Subject: Oconee Nuclear Station
Docket Numbers 50-269, 270, and 287
Supplement to License Amendment Request
associated with the Passive Low Pressure
Injection Cross Connect Modification
Technical Specification Change (TSC) Number
2003-02

In a submittal dated March 20, 2003 Duke proposed to amend Appendix A, Technical Specifications, for Facility Operating Licenses DPR-38, DPR-47 and DPR-55 for Oconee Nuclear Station, Units 1, 2, and 3 to support installation of a passive LPI Cross Connect inside containment. The proposed License Amendment Request (LAR) revises the licensing basis associated with a selected portion of the Core Flood (CF) and Low Pressure Injection (LPI)/Decay Heat Removal (DHR) piping to allow the exclusion of dynamic effects associated with postulated pipe rupture of that piping by application of leak-before-break (LBB) technology for Oconee Unit 1. The proposed LAR also revises the licensing basis for selected portions of the LPI/DHR piping to adopt Standard Review Plan (SRP), Section 3.6.2, Branch Technical Position (BTP) MEB 3-1 design requirements. The proposed LAR adds Technical Specification (TS) requirements for the passive LPI cross connect and eliminates

Figure 1. True Stress - True Strain for Type 304SS at 75°F

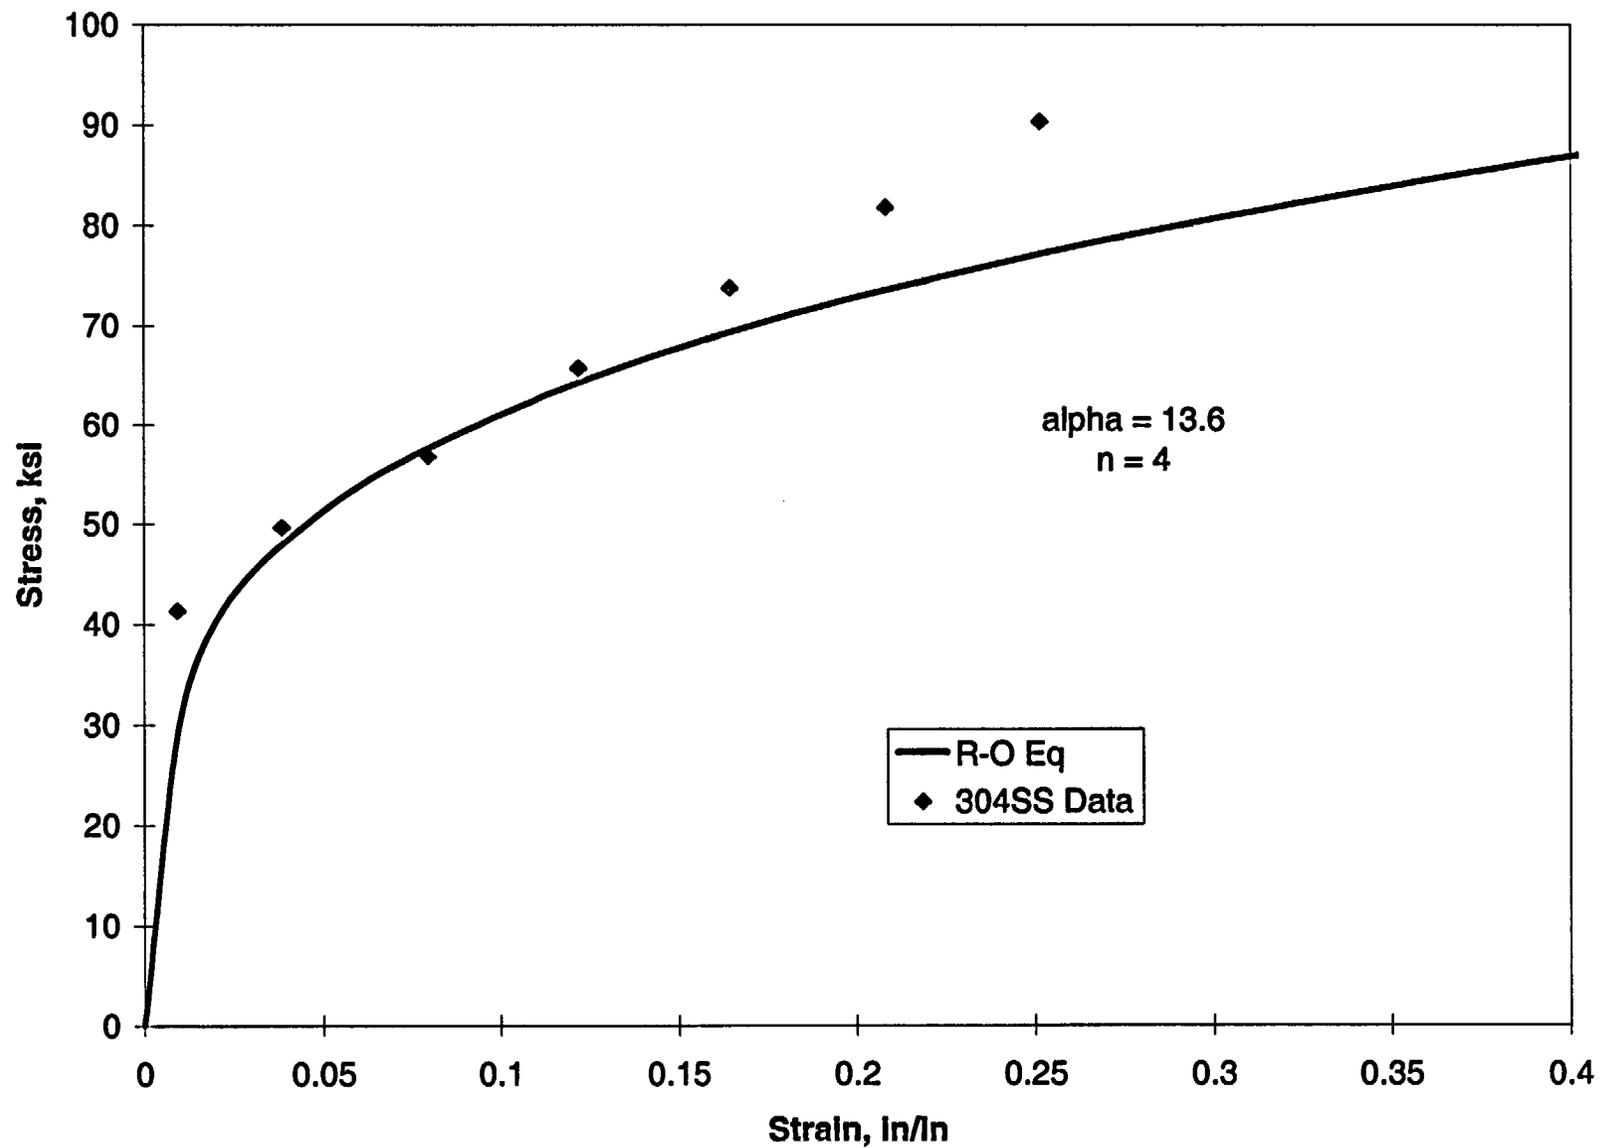
RAI-6 Figure 3-1 is meant to show the Ramberg-Osgood stress-strain equation fit to the experimental data of Reference 11, but it shows, instead, the fit of a J-R curve. Provide a revised Figure 3-1.

RESPONSE The LBB topical report has been revised to include the revised figure (See attached Figure 1).

Figure 2. Leakage Size Cracks Considering Various Ramberg-Osgood Parameters at Piping Location 2

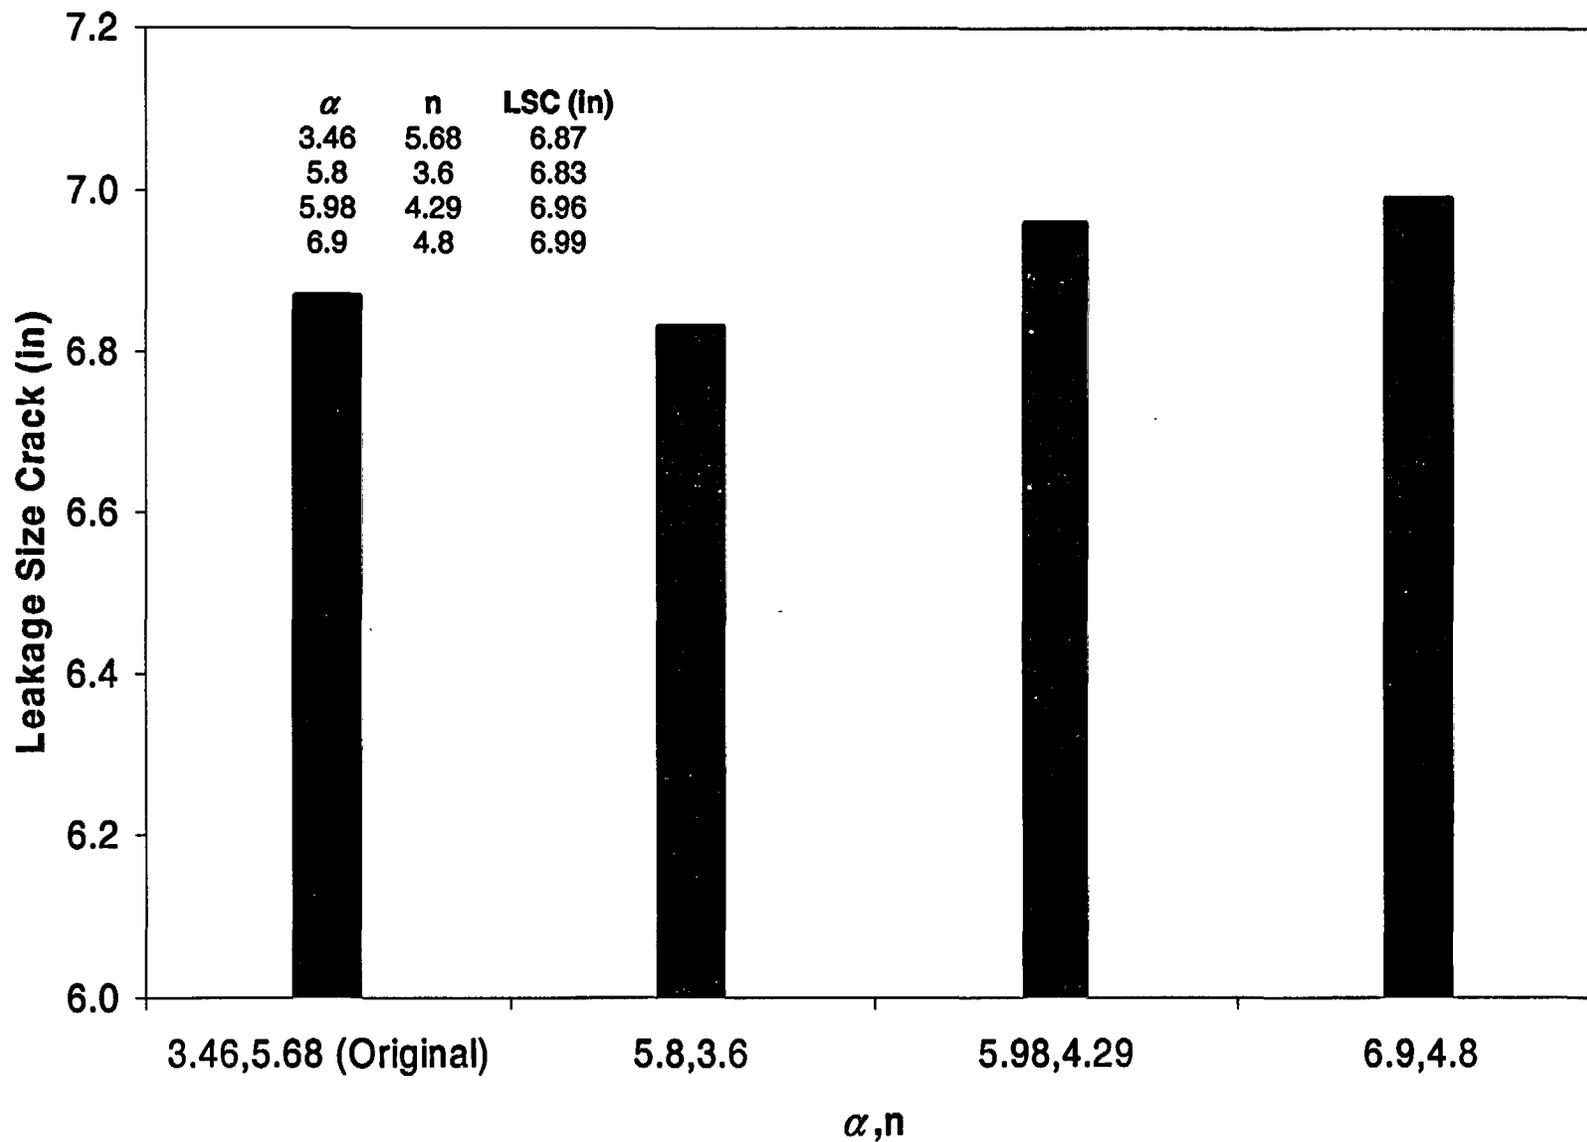
RAI-7 The Ramberg-Osgood parameters for the same material from different sources may be quite different. For instance, you reported (α, n) of (8.0, 3.5) for 304 stainless steel (SS) base metal and (α, n) of (0.565, 8.28) for 316 stainless steel base metal at 550°F. However, the Ramberg-Osgood parameters are reported to be (5.98, 4.29) for 304 SS base material in EPRI NP-3596-SR, Revision 1, "PICEP: Pipe Crack Evaluation Program (Revision 1)," and (6.9, 4.8 or 5.8, 3.6) for 316 SS base material in an NRC safety evaluation, "Staff Review of the Submittal by Rochester Gas and Electric Company to Apply Leak-Before-Break Status to Portions (of) the R.E. Ginna Nuclear Power Plant Residual Heat Removal System Piping [TAC NO.: MA0389]," dated February 4, 1999. Assess the impact to margins on flaw size due to uncertainty of (α, n) at such a magnitude. The assessment should include all materials in Table 7-1 of your submittal.

For piping location 2, the R-O parameters for both the 304 SS (5.98, 4.29) and 316 SS materials (6.9, 4.8 or 5.8, 3.6) were considered to conservatively bound the 316 SS material at the location. As depicted in Figure 2, the predicted 10 gpm leakage crack sizes ranged from 6.83 inches to 6.99 inches. Therefore, the maximum leakage crack size of 6.99 inches (obtained using α , and n values of 6.9 and 4.8, respectively) is conservatively considered in this assessment.

Figure 3. J versus T Diagram for 304SS Base Metal at LBB Location 1

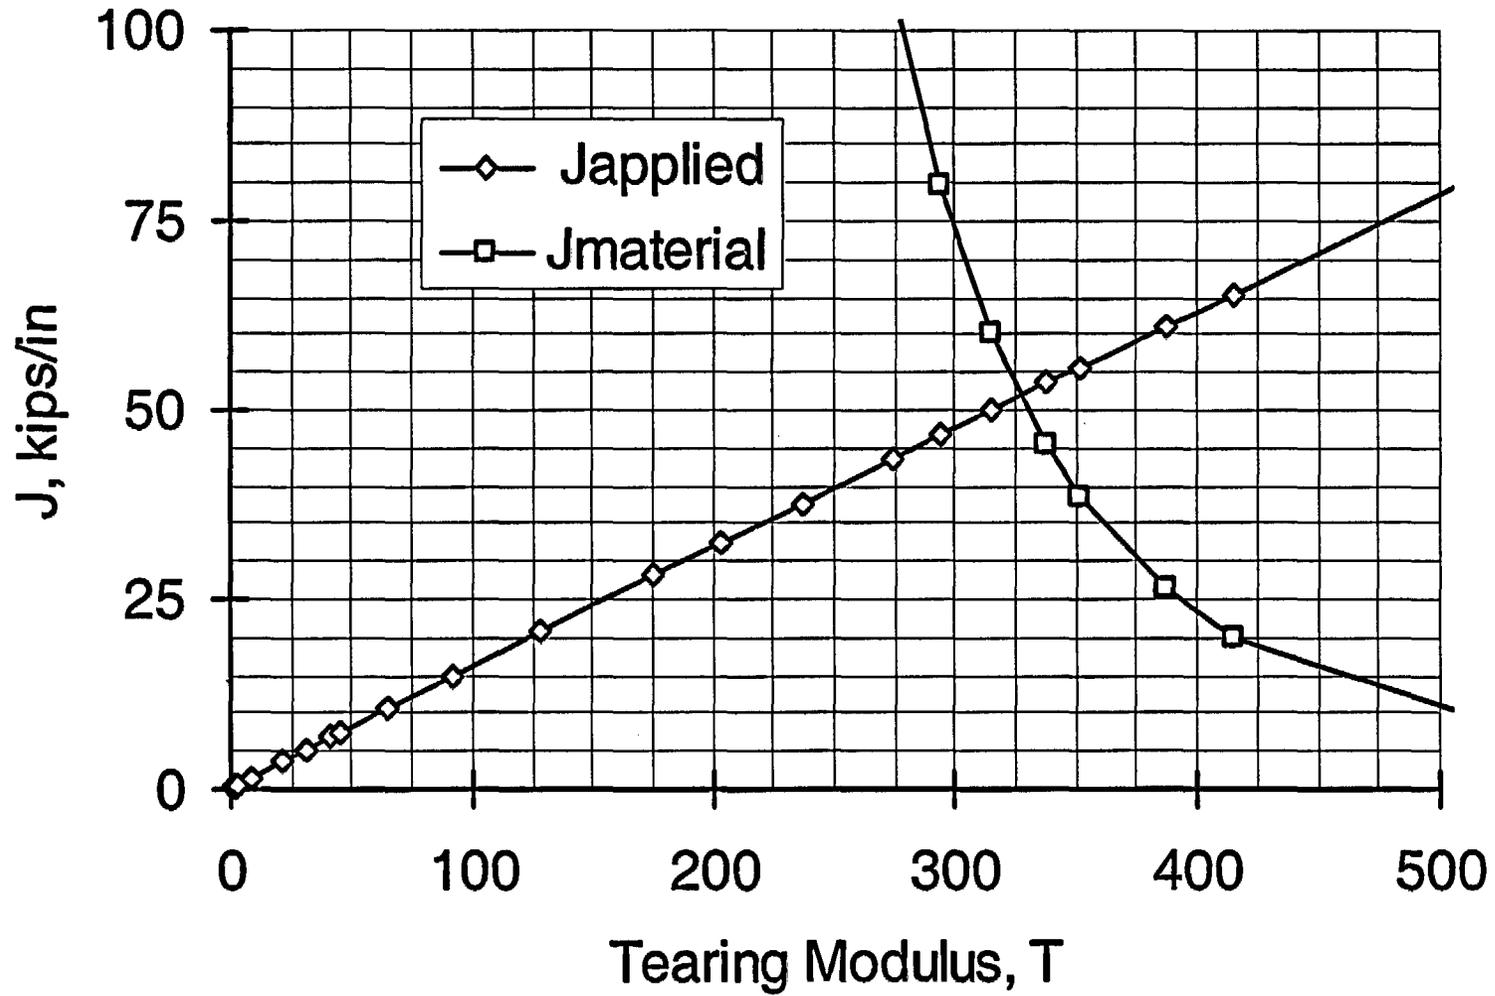
RAI-9 The J-T analysis has become a little complex by your consideration of an additional parameter $J_{upper\ limit}$. Explain the need to have $J_{upper\ limit}$ included in your stability analysis.

RESPONSE In the J-T Analysis summarized in the topical report, Framatome ANP considered an additional limit on J, called $J_{upper\ limit}$, which is less than $J_{instability}$ in a J-T analysis, as an added conservatism. $J_{upper\ limit}$ is based on the J at maximum crack extension from an actual compact test specimen. This approach is eliminated when performing the new J-T analysis whose results are reported in Tables 1 and 2 and Figures 3 through 7.
